Groundwater Application Review Summary Form

Application # G- 18850 - RR

PUBLIC INTEREST REVIEW FOR GROUNDWATER APPLICATIONS

TO: Water Rights Section Date 12/16/2019
 FROM: Groundwater Section M Thoma
 Reviewer's Name
 SUBJECT: Application G- 18850 Supersedes review of 09/17/2019*
 Date of Review(s)

Well Location Map

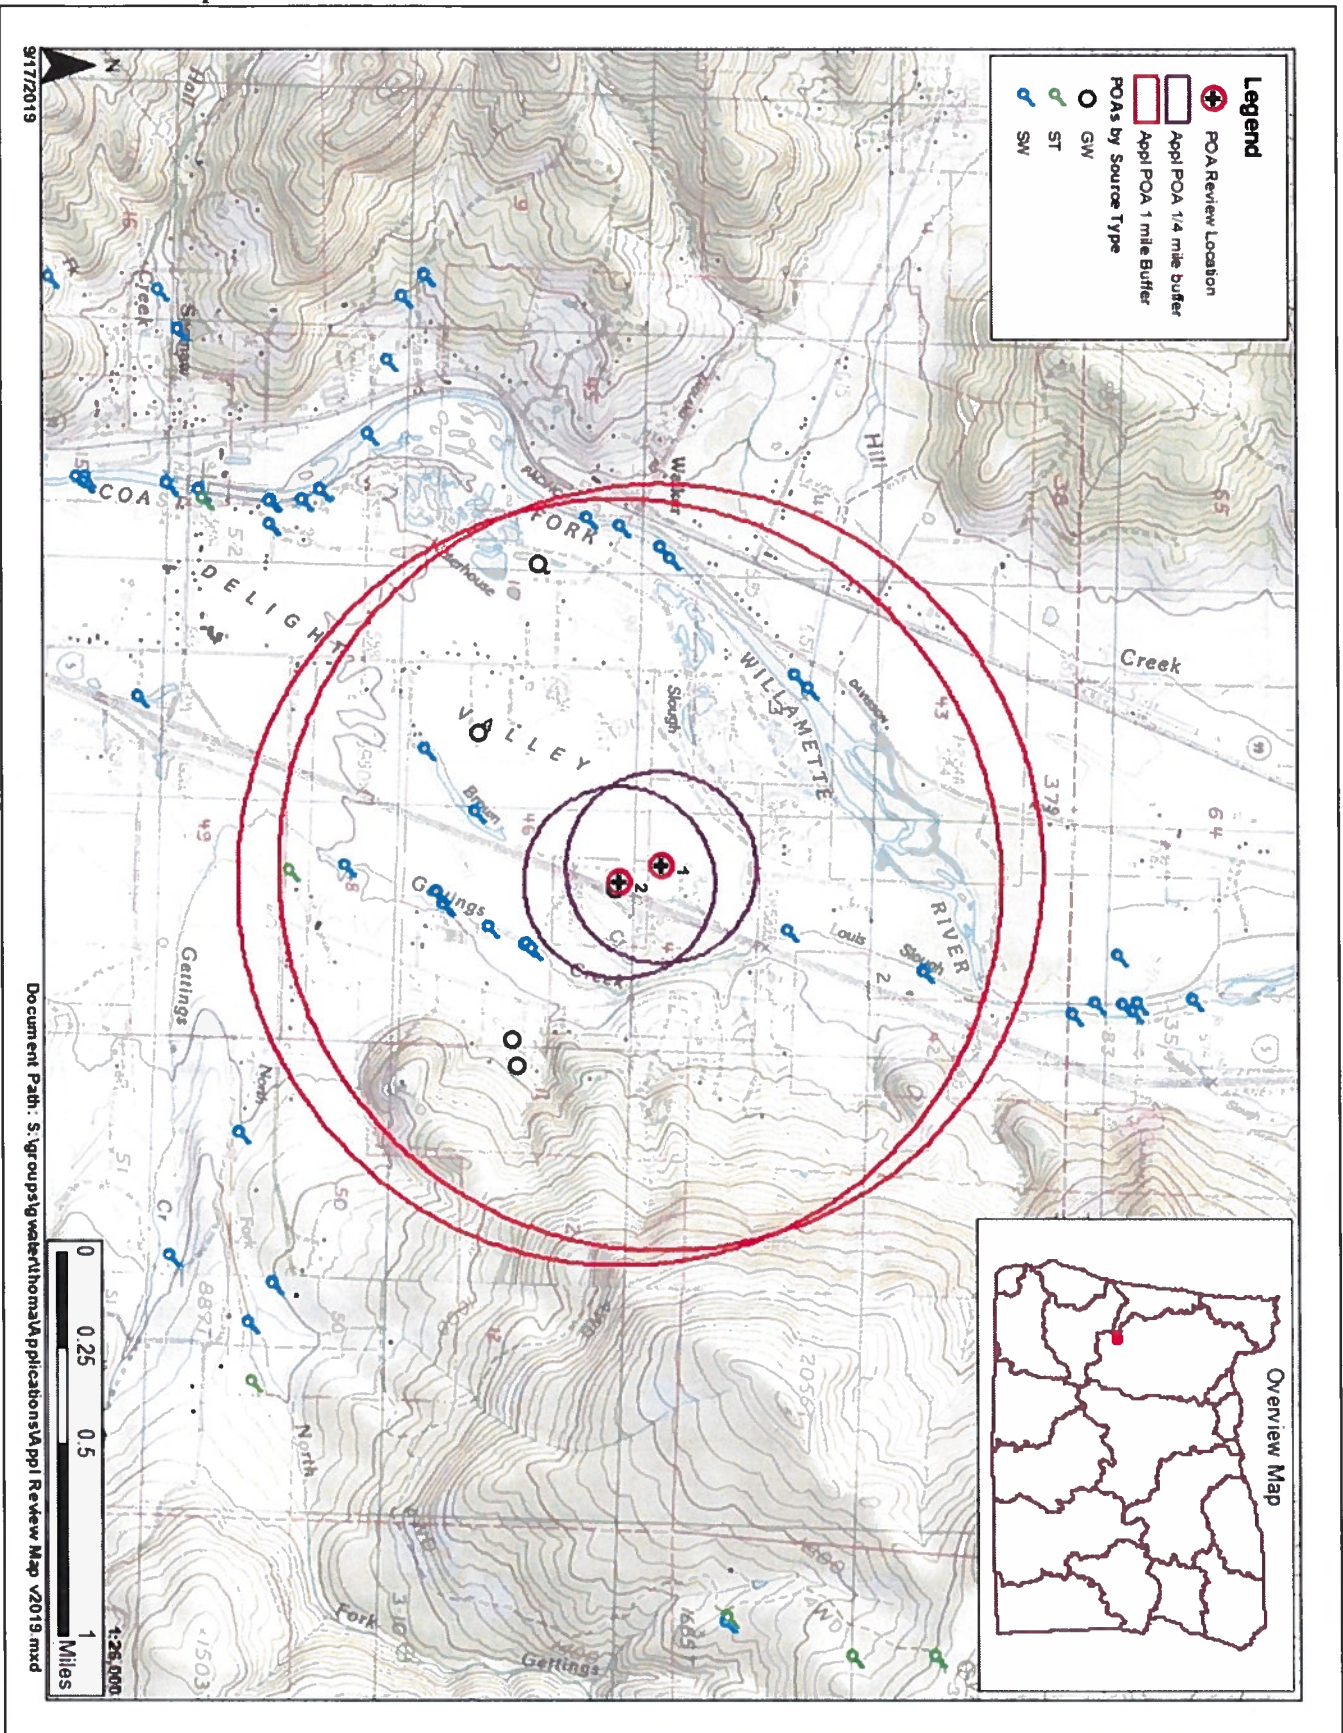
B3. **Groundwater availability remarks:** The applicant’s proposed POAs are near a current State Obs Well (SOW #476) that has reported water-level data going back to 1966. These data show a long-term stable trend suggesting that groundwater has not been Over-Appropriated. However, a detailed analysis of groundwater recharge vs. allocation has not been performed for this area so Over-Appropriation cannot be definitively concluded.

There are four permitted groundwater rights within 1 mile of the proposed POAs with the nearest being approx. ½ mile from POA #2 (the nearest mapped POA is on the same well as the applicant’s POA #2 and so is not evaluated for injury). Two of the POAs are located uphill from the proposed POAs and will not likely be affected by the new use. The other two POAs are located on the floodplain with the proposed POAs but one POA is described as a “sump” and appears to be a meander scar of the Coast Fk Willamette and the other is describes as 50 ft deep. These POAs would thus likely be producing from the shallow alluvial deposits overlying the bedrock targeted by the applicant’s POAs and so would not likely be injured by the new proposed use despite continuous hydraulic connection between the shallow and deep zones, however, standard interference conditions should be applied.

Stream-Depletion Model Results

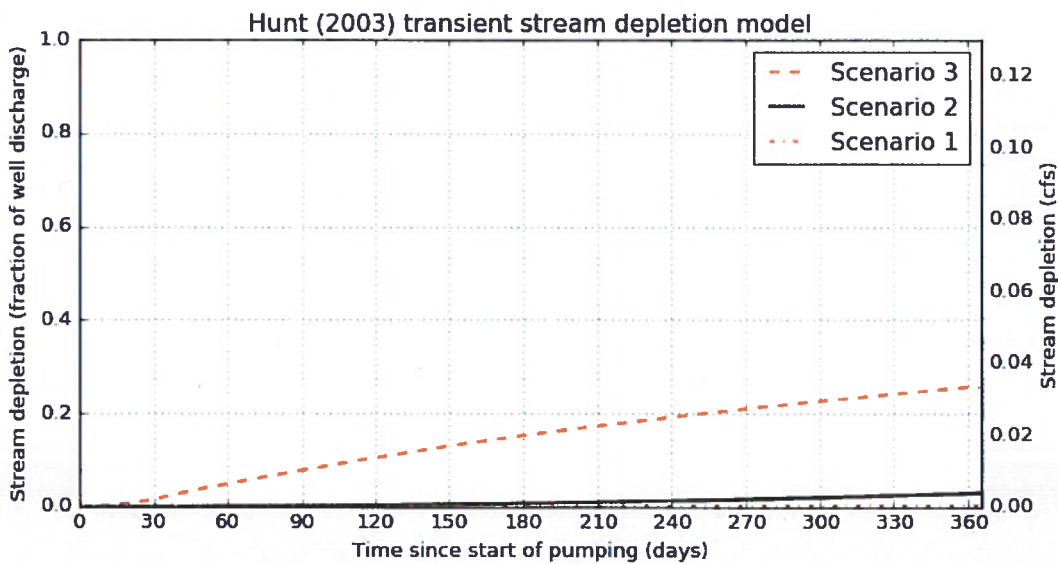
Comments: stream-depletion was estimated using the Hunt-2003 model with parameter values assigned from a range that represents likely values for the given aquifers.
 POA #2 is assumed to have the Potential for Substantial Interference because it is within ¼ mile of Gettings Creek and has been found to be producing from an aquifer that is hydraulically-connected to surface water (see OAR 690-009-0040(4)(a)).

C6. **SW / GW Remarks and Conditions:** The applicant's proposed POAs would be producing from an aquifer that has been found to be hydraulically connected to surface water – specifically Gettings Creek and the Coast Fk Willamette River – at distances of less than 1 mile. POA #2 is within ¼ mile of Gettings Creek and found to be hydraulically-connected so, per OAR 690-009, POA #2 is assumed to have the Potential for Substantial Interference. POA #1 is also found to be hydraulically-connected to Gettings Creek but is at a distance of greater than ¼ mile and so POA #1 is assumed to not have the Potential for Substantial Interference. Both POAs are also found to be hydraulically-connected to the Coast Fk Willamette River at distances greater than ¼ mile. For both POAs, the proposed maximum rate of appropriation is less than 1% of the pertinent adopted perennial streamflow and also less than 1% of the adopted instream water rights for either surface water source and stream-depletion is estimated to be less than 25% at 30 days.
